# Service Bulletin

**SUBJECT:** Service Update for Inventory and Customer Vehicles  
Turbo-to-Exhaust Manifold Joint May Relax  
Expires with Base Warranty

**MODELS:** 2013 Cadillac ATS  
2013 Chevrolet Malibu  
Equipped with 2.0L Engine (LTG)

3268362

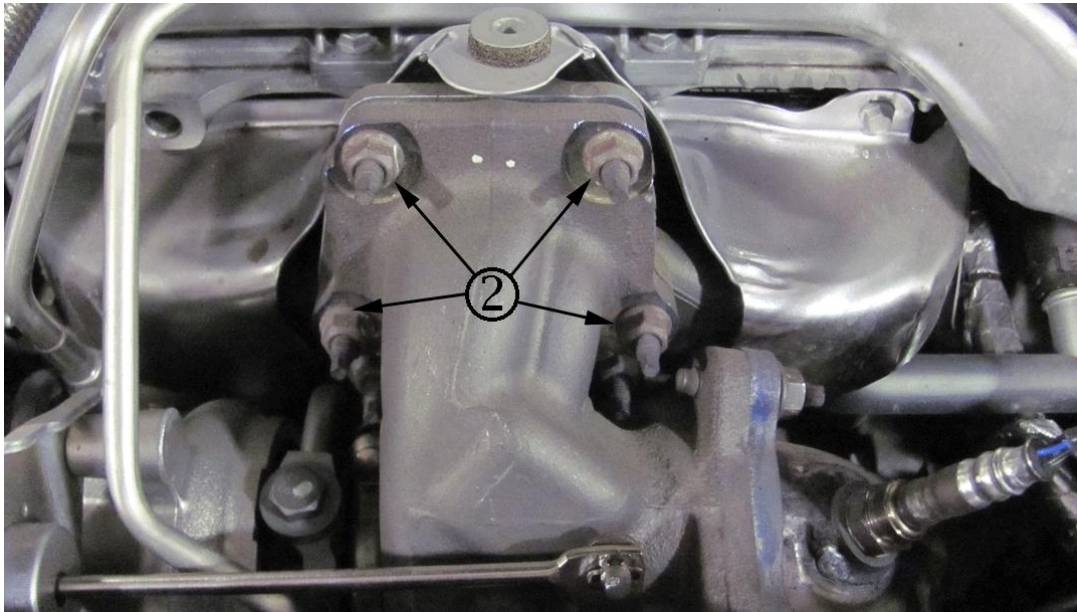
The service procedure in this bulletin has been revised to add Step 4, which instructs technicians to loosen the 4 turbocharger-to-exhaust manifold bolts prior to tightening them. Please discard all copies of bulletin 13013.

This bulletin provides a service procedure to tighten all 4 exhaust manifold bolts on **certain** 2013 model year Cadillac ATS and Chevrolet Malibu vehicles, equipped with a 2.0L engine (LTG). The ring gasket may be pinched between the flanges on the inside diameter of the joint leading to a visible gap. As the pinched part of that gasket relaxes, clamp load is lost at that stud location.

2. Locate the turbocharger exhaust heat shield (1).

3. Remove the turbocharger exhaust heat shield. Refer to *Exhaust Manifold Heat Shield Replacement (LTG)* in SI.

4. Loosen the four turbocharger-to-exhaust manifold nuts (2).
5. Tighten the four turbocharger-to-exhaust manifold nuts (2) to **30 Nm (22 lb-ft) + 90 degrees**.
6. Re-install the turbocharger exhaust heat shield. Refer to *Exhaust Manifold Heat Shield Replacement (LTG)* in SI.
7. Tighten turbocharger exhaust manifold heat shield fasteners to **9 Nm (80 lb-in)**.
8. Close the hood of the vehicle.
